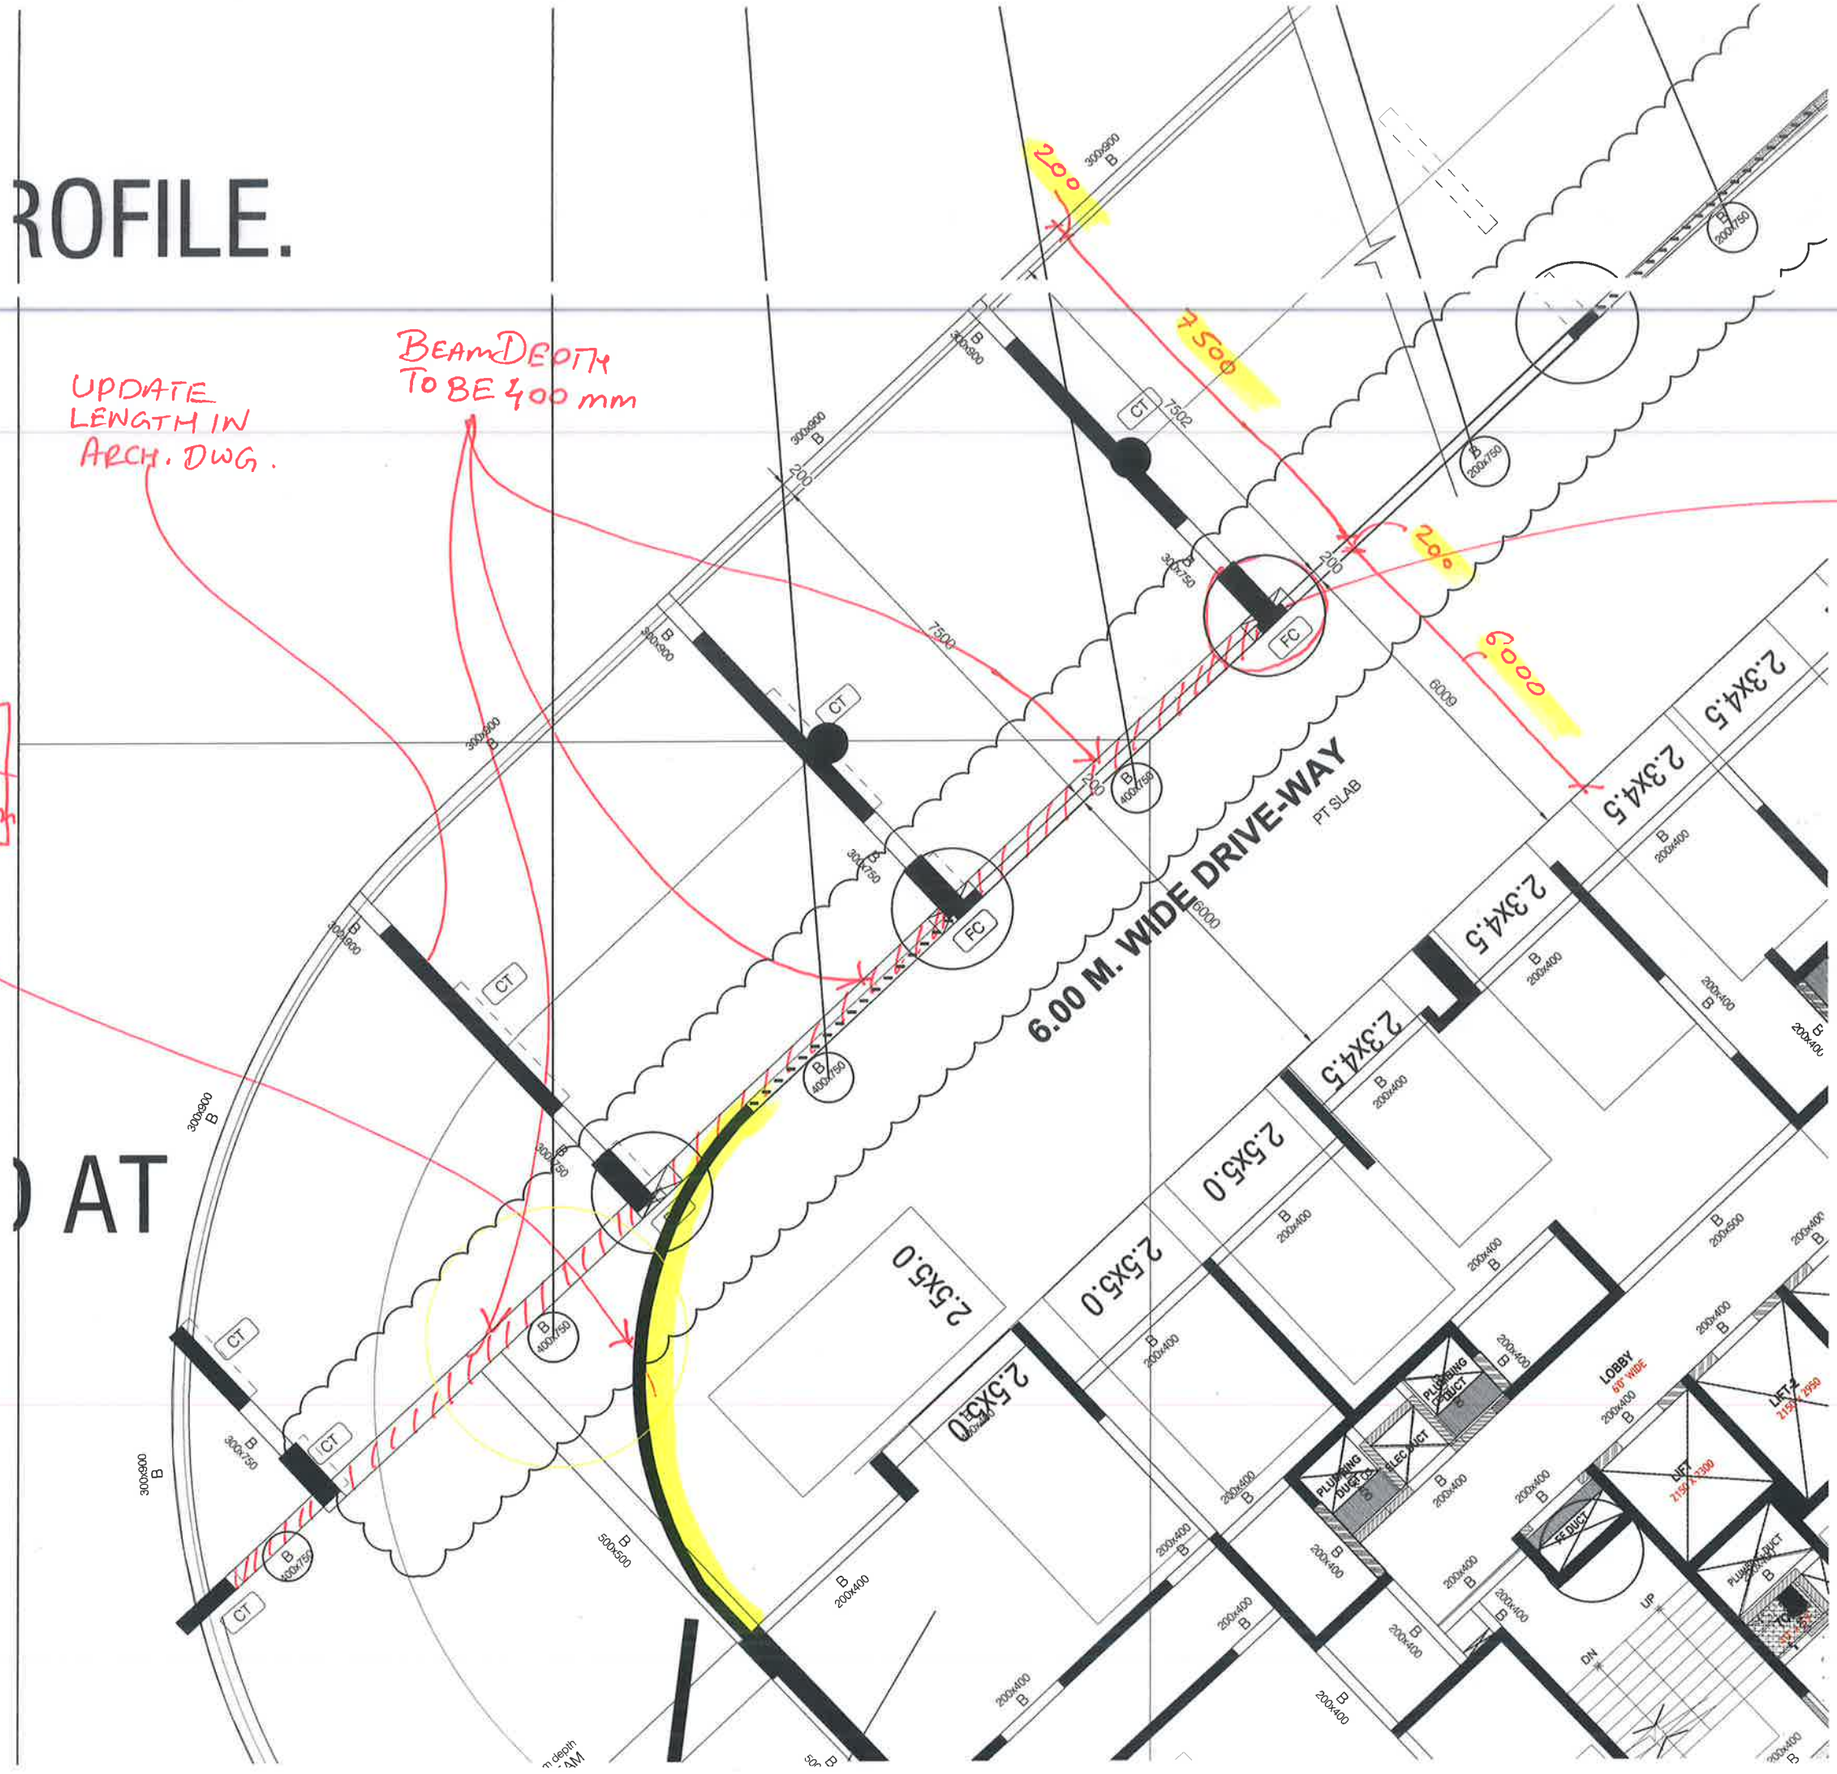
UPDATE LENGTH IN ARCH. DWG.

BEAM DEPTH TO BE 400 mm

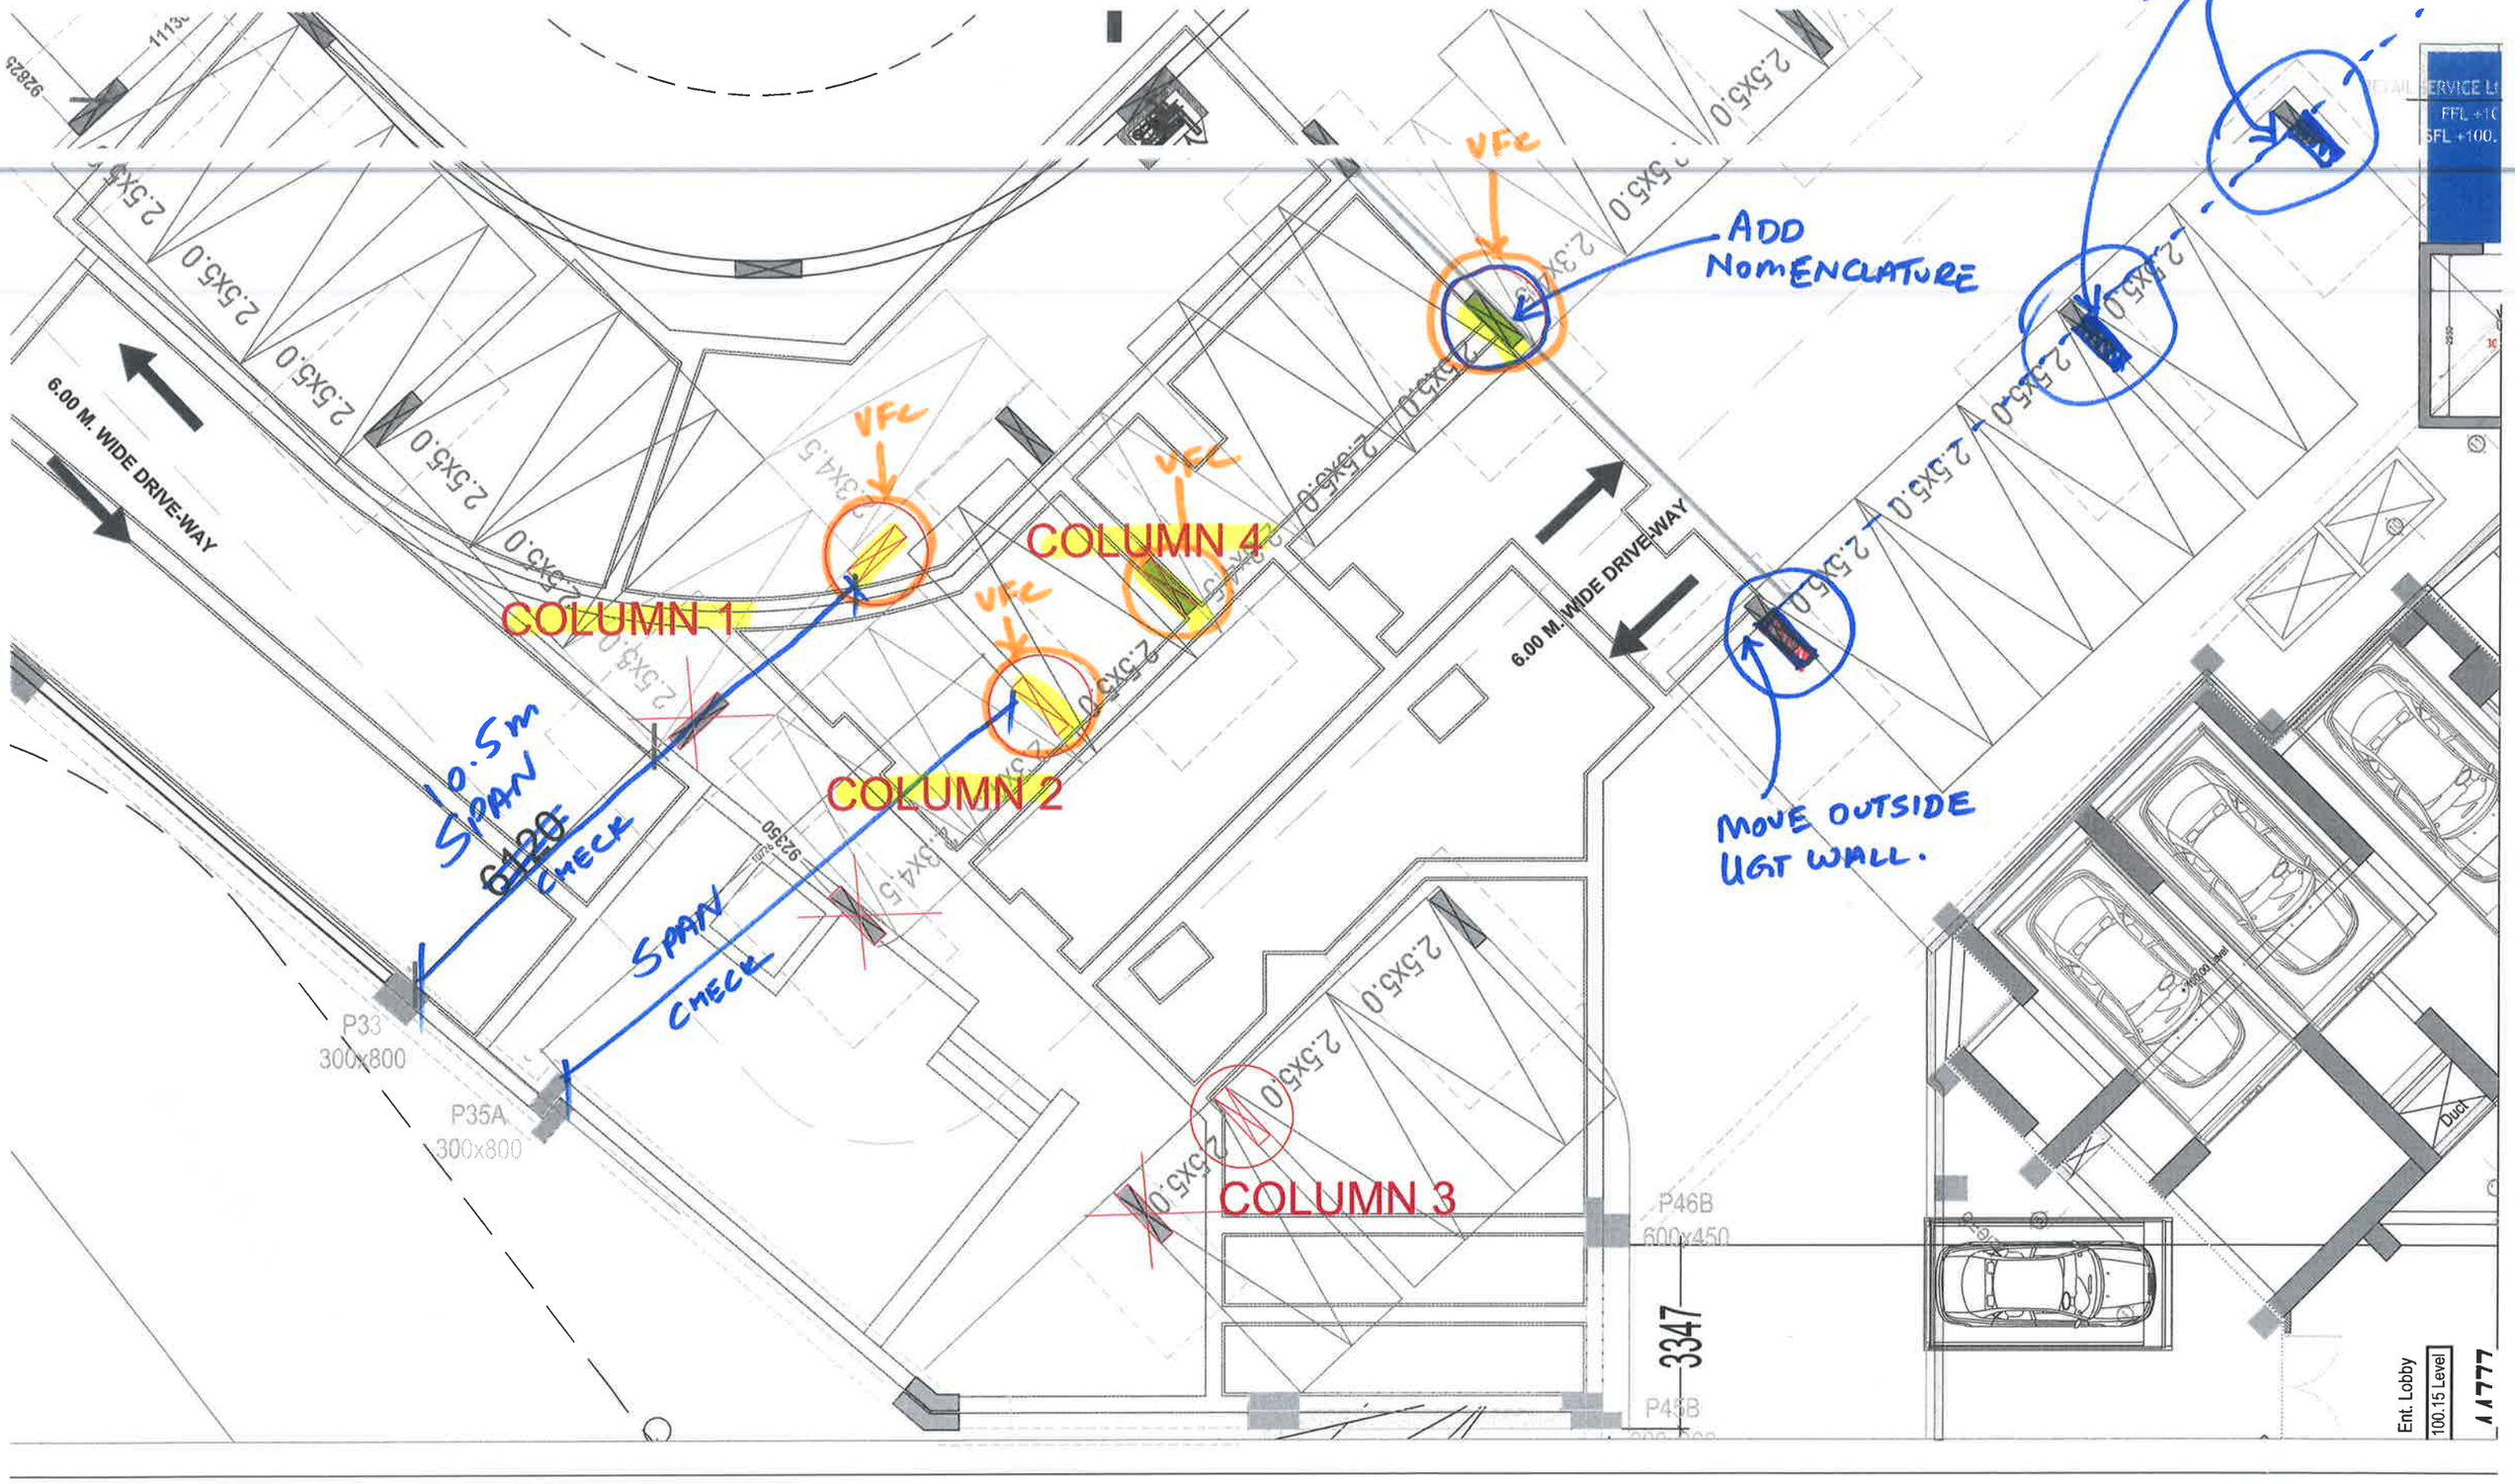
JW TO CHECK CURVED BEAM

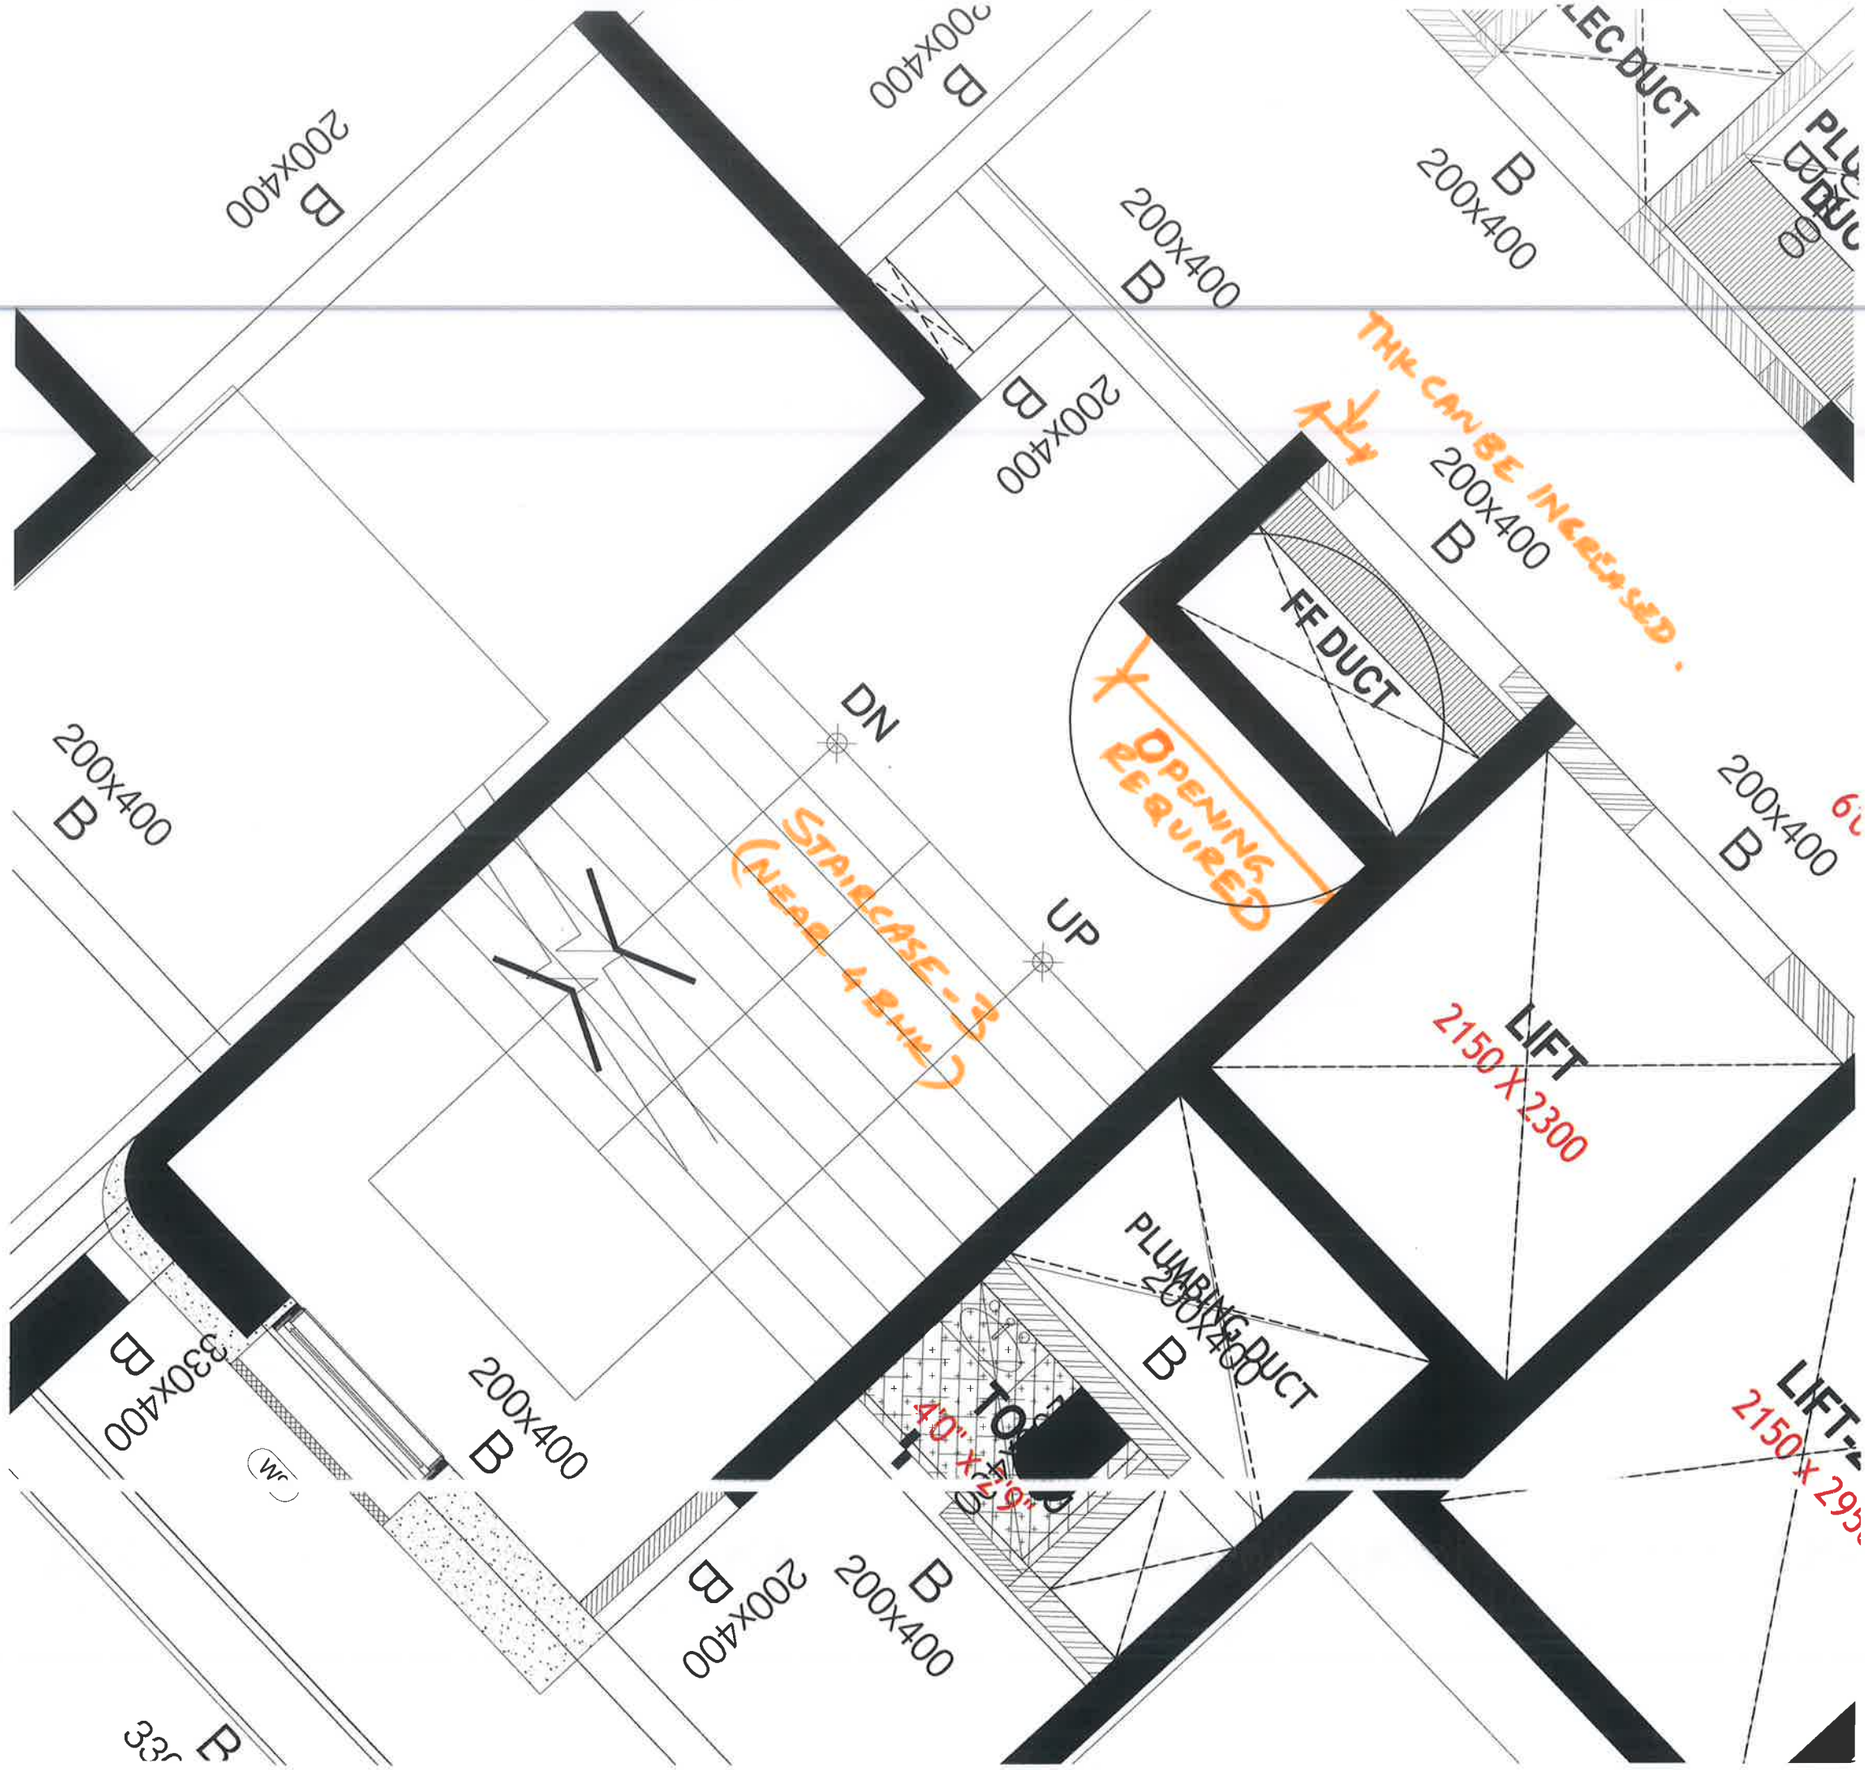
ALIGN ACCORDINGLY
ADD NOMENCLATURE
MOVE OUTSIDE UGT WALL.
VFL
VFL
VFL
COLUMN 1
COLUMN 2
COLUMN 3
COLUMN 4
6.00 M. WIDE DRIVE-WAY
6.00 M. WIDE DRIVE-WAY
10.5m SPAN CHECK
SPAN CHECK
2.5X5.0
2.3X4.5
2.5X4.5
P33
300x800
P35A
300x800
P46B
600x450
3347
FFL +10
SFL +100.
Duct
Ent. Lobby
100.15 Level

B
200x400
DN
UP
STAIRCASE-3
(NEAR LIFT-3)
THIS CAN BE INCREASED.
OPENING REQUIRED
FF DUCT
LIFT
2150 X 2300
PLUMBING DUCT
200X400
TOP
40" X 29"
LIFT-4
2150 x 29
330X400
WC
200x400
